Report: TAB Report
Function: Test, Adjust, & Balance
Date: 05/06/2025
Completed By: National TAB

05-05-25 CHIPOTLE #5558 OWATONNA, MN

Project: 05-05-25 CHIPOTLE #5558 OWATONNA, MN

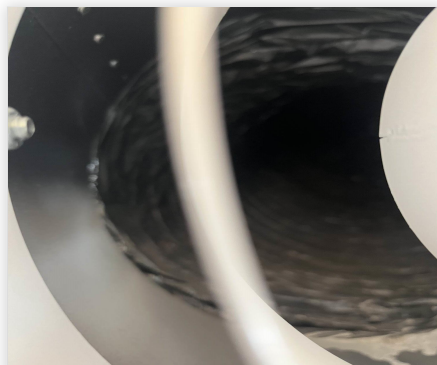
Issue Name : RTU-2: Accessible Dampers Not Installed
Description : Per grille schedule, installed SR1 and SR2 grilles to have face accessible OBDs. None are installed. It appears dampers were installed closer to the takeoffs for several Grilles, but these are not accessible due to ceiling obstructions. Total airflow for the unit is at design and unit serves large space, not anticipated to cause issue.

- **05/06/2025 National TAB - Michael McDonnell**
 - Some Dampers installed near branch takeoffs. These are not accessible and not called for on plans.
